SUNDRY NOTICES AND REPORTS ON WELLS
Do not use this form for proposals to drill or to re-enter an abandoned well. Use Form 3160-3 (APD) for such proposals.

REQUEST TO PLUG AND ABANDON WELL PER THE ATTACHED PROCEDURE. ATTACHMENTS ALSO INCLUDE CURRENT/PROPOSED WELLBORE DIAGRAMS AND RECLAMATION PLAN.

WELL: JICARILLA B-22

API: 30-039-05665

PROPOSED P&A WELLBORE DIAGRAM

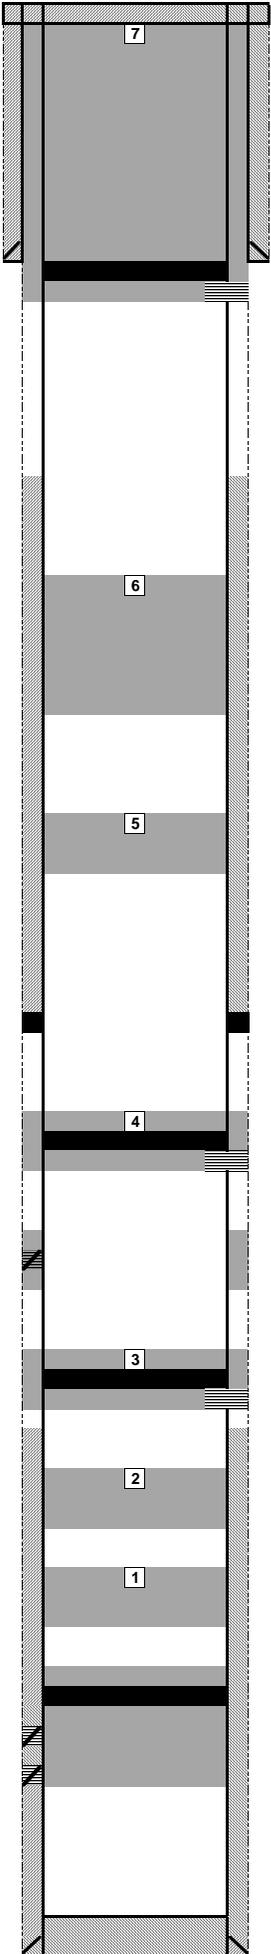
- BLM pick for the top of the Pictured Cliffs formation varies from Operator.

- Bring the bottom of Plug #6 down to 2623' to cover BLM Pictured Cliffs pick (2573').

1. Plugging operations authorized are subject to the attached "General Requirements for Permanent Abandonment of Wells on Federal and Indian Lease."
2. The following modifications to your plugging program are to be made:
 - a) Bring the bottom of Plug #6 down to 2623' to cover BLM Pictured Cliffs pick (2573').
3. Farmington Office is to be notified at least 24 hours before the plugging operations commence at (505) 564-7750.
